## **MCI Service Bulletin - Increase in GVW**

# **Service Bulletin No. 2822**

MODEL	ТҮРЕ	SECTION/GROUP	DATE	
102 E / E4500 Series Coaches	Product Improvement	3 - Body	April 12 / 02	
SURJECT ADDITIONAL CERTIFICATION DECAL				
CONDITIONS

Figure 1.

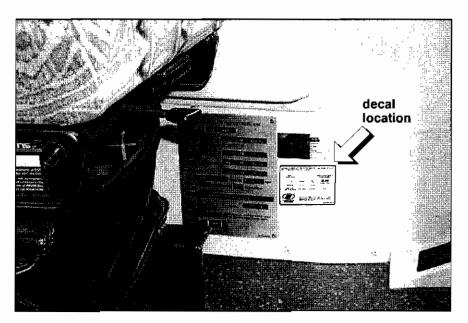
- 1. Open the entrance door.
- Locate the MCI Certification Plate on the driver kick panel, across from entrance door and below drivers seat. Clean the surface where the decal is to be applied (location shown in Figure 1), with a clean rag and isopropyl alcohol.

Figure 2.

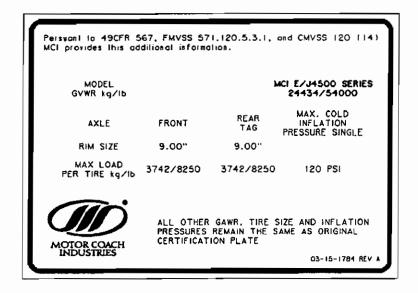
As identified on the label, the GVWR is increased from 49,900 lb to 54,000 lb. The front axle Gross Axle Weight Rating (GAWR) may also be increased from 16,000 lb to 16,500 lb depending on the rim weight limitations.

3. Apply the decal (Figure 2) on the designated area.
